**ADDENDUM NO. 01****BILLINGS MET ADDITION AND REMODEL****1705 MONAD RD, BILLINGS, MT 59101**

Architect's Project No: 2329

Date Issued: 1-Mar-24

ARCHITECT: COLLABORATIVE DESIGN ARCHITECTS, INC.
2280 Grant Road – Suite C
Billings, Montana 59102
(406) 248-3443

1 PARAPET CAP

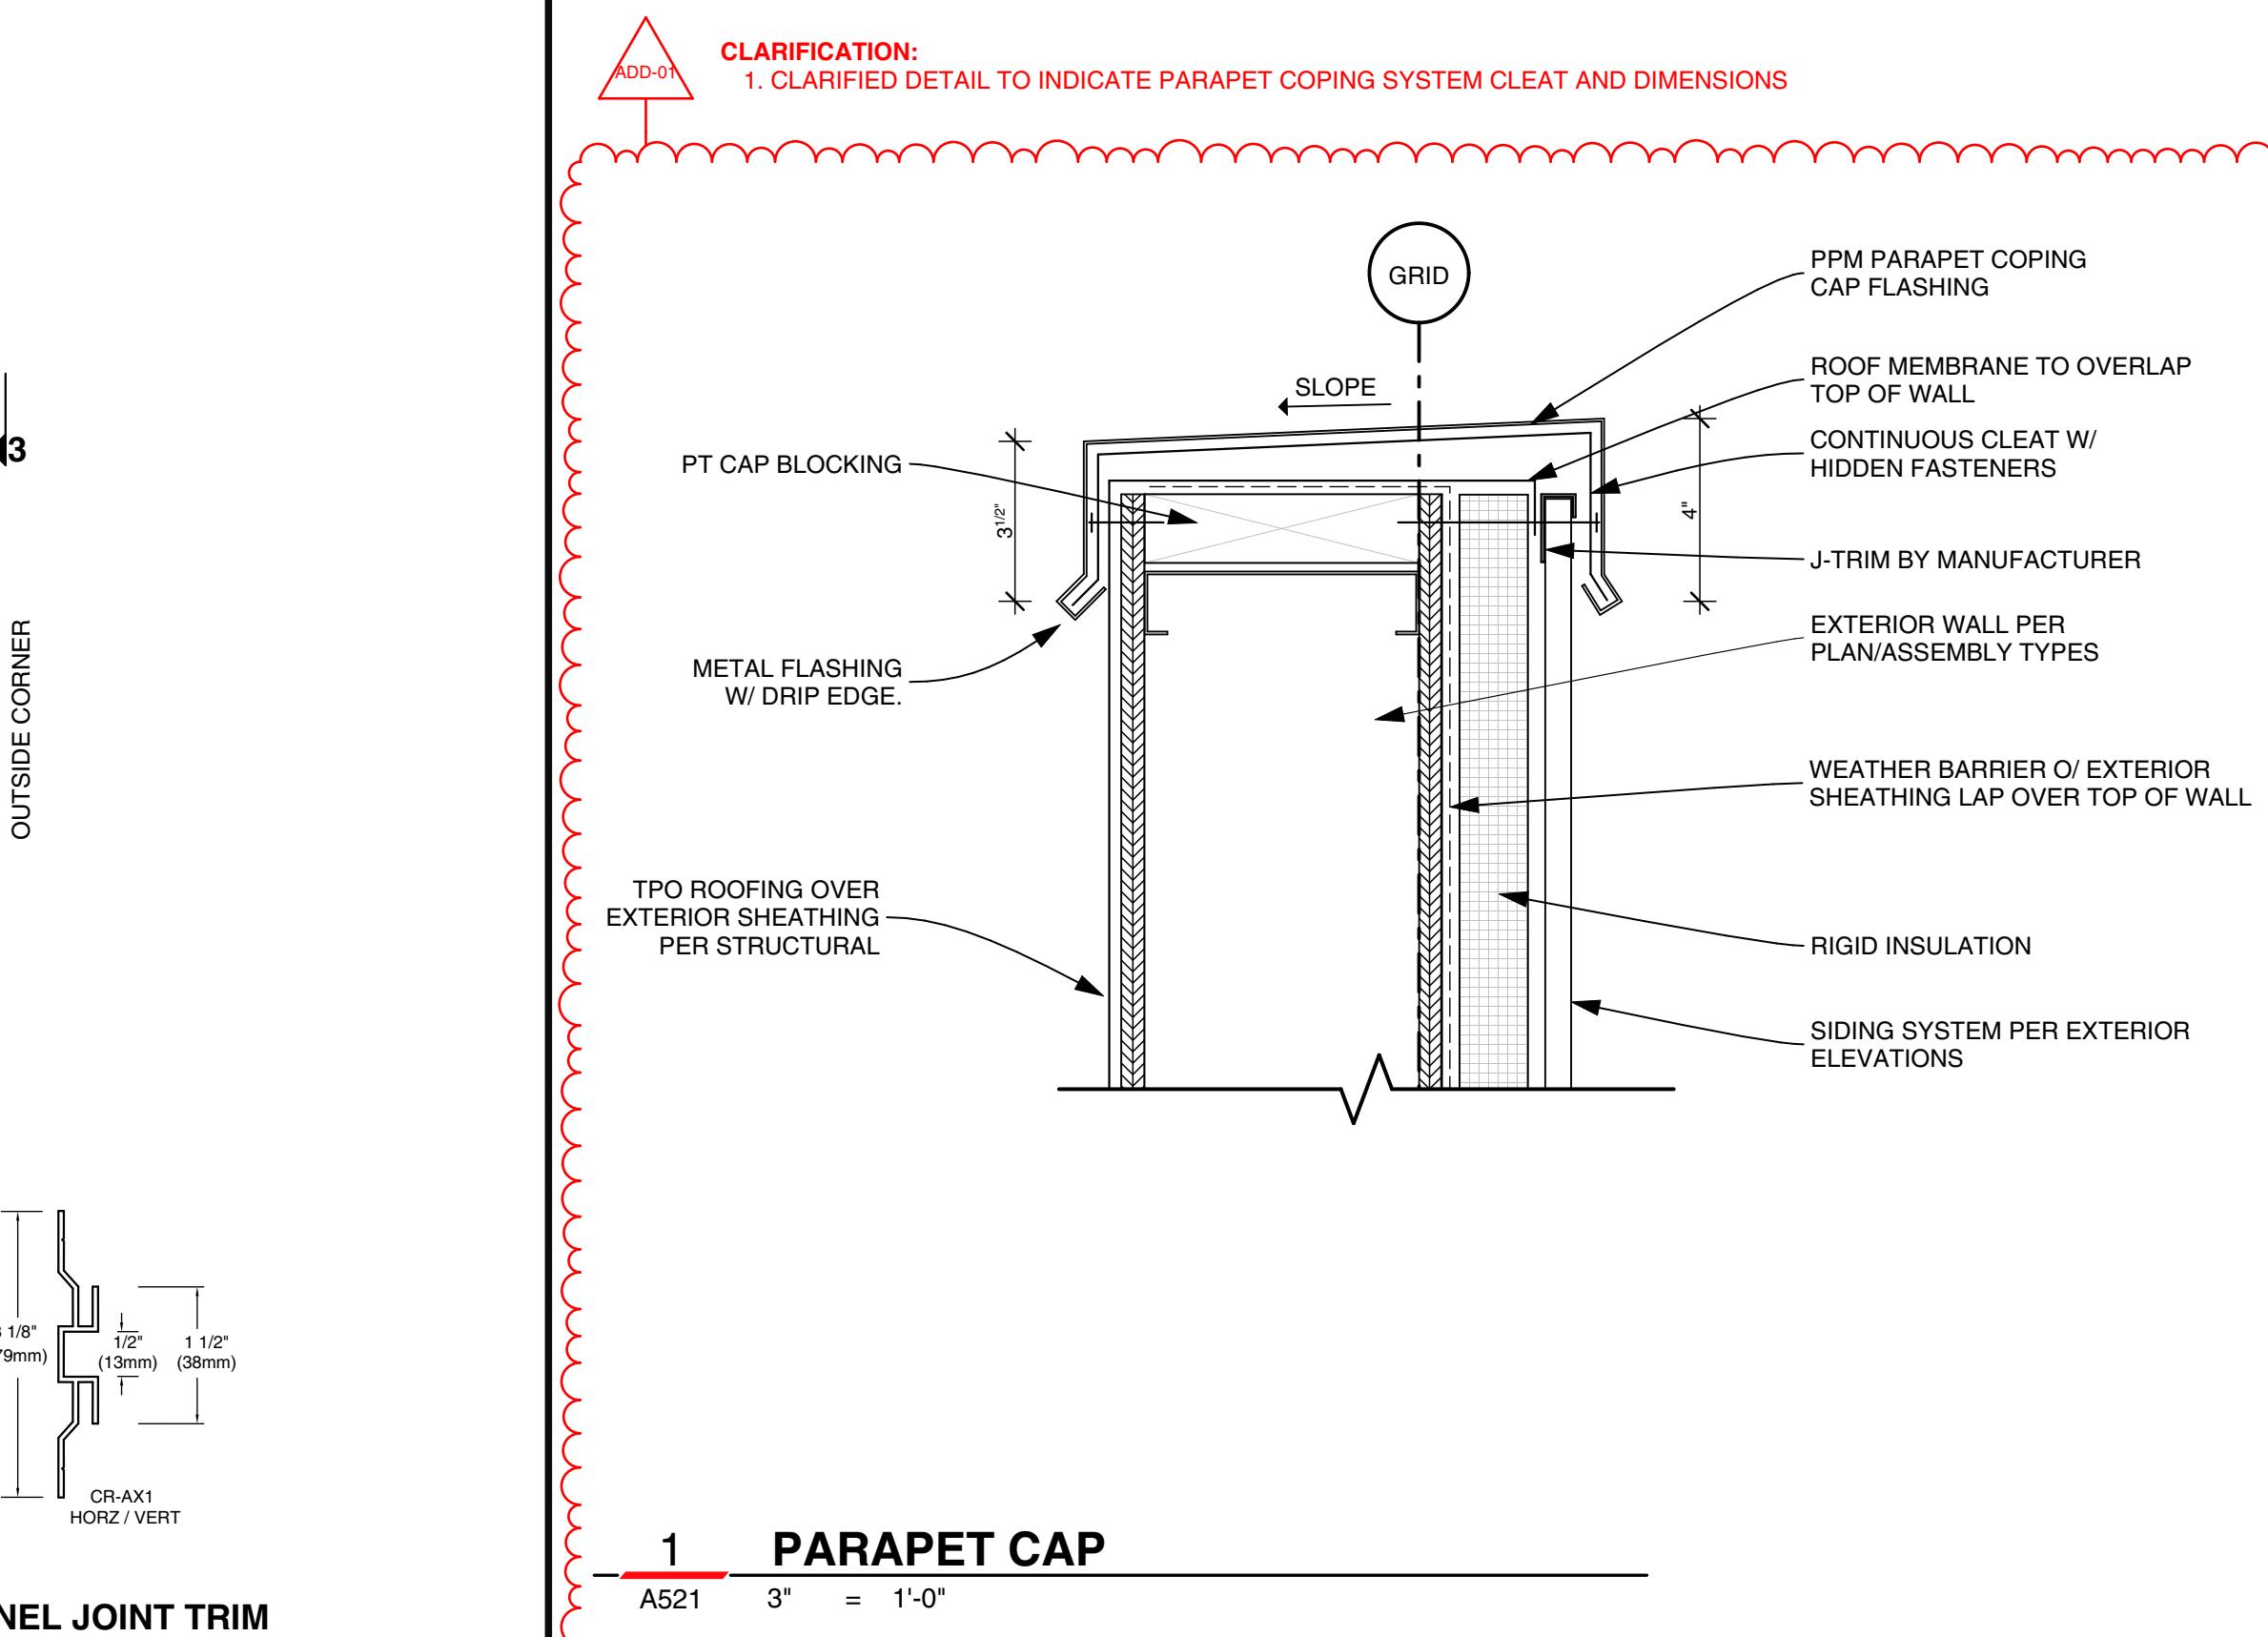
01.2.9	A521	REPLACE sheet in its entirety. Revisions are clouded. CLARIFICATION: 1. CLARIFIED DETAIL TO INDICATE PARAPET COPING SYSTEM CLEAT AND DIMENSIONS
